New Albany Architectural Review Board Agenda

Monday, May 9, 2022 7:00pm

SIMPLY QUARTERED WALL SIGNS CERTIFICATE OF APPROPRIATENESS & WAIVER

LOCATION:29 South High StreetAPPLICANT:Chad ThompsonREQUEST:Certificate of Appropriateness & WaiverZONING:Urban Center, Historic Center Sub-DistrictSTRATEGIC PLAN:Village CenterAPPLICATION:ARB-51-2022

Wall Sign Board #1

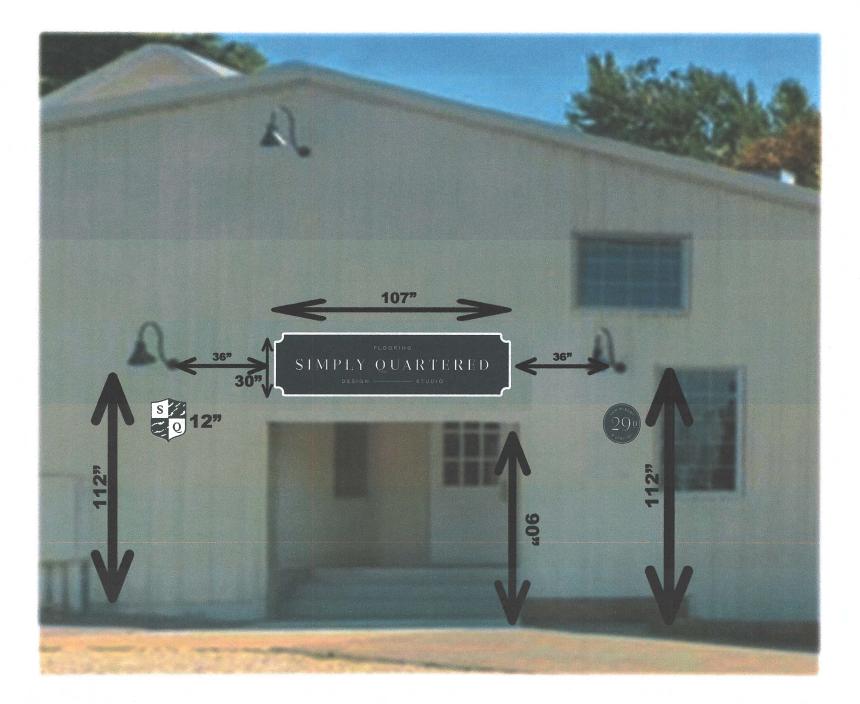
- City sign code Chapter 1169.16(d) permits a maximum area of 30 square feet based on the building's frontage and allows one wall sign per business entrance and requires a minimum sign relief of one inch. The building has 43+/- feet of frontage on Locust Alley. External illumination is allowed.
 - *a.* Area: 22.29 square feet [meets code].
 - *b.* Location: the sign is proposed to be installed above the main tenant entrance along Locust Alley. [meets code].
 - c. Lighting: none proposed [meets code].
 - d. Relief: 1 inch [meets code].
 - *e*. Colors: midnight blue, cool gray and cream (total of 3) [meets code].
 - f. Lettering Height: 12" [meets code]
- The sign will read "Flooring | Simply Quartered | Design—Studio
- The sign panel is made out of HDU which is a permitted sign material.

- <u>C.O. 1169.16(d)(2) states that a maximum of one wall sign is permitted per building entrance. The applicant proposes to install two wall signs therefore a waiver is required and will be evaluated under the waiver section of the staff report.</u>

- 1. C.O. 1169.16(d)(2) states that one wall sign is permitted to be installed per business entrance. The tenant space has one entrance on Locust Alley and the applicant proposes to install two wall signs therefore, a waiver is required.

- 2. The intent of code requirement is to ensure that buildings and/or individual tenant spaces are not over signed. C.O. 1169.16(d) allows one wall sign by right at this tenant space based on the building's frontage along Locust Alley. While the applicant proposes to install two wall signs, the combined area of the signs is 23.12 sq. ft which is below the total allowable area for just one sign by right. For this reason, it appears that the intent of the standard that the applicant is attempting to seek a waiver from has been substantially met.

Staff recommends approval of this application provided that the ARB finds that the proposal meets sufficient basis for approval. The proposed wall signs appear to be consistent with the architectural character of the site as well as the overall Village Center and are appropriate for this space.
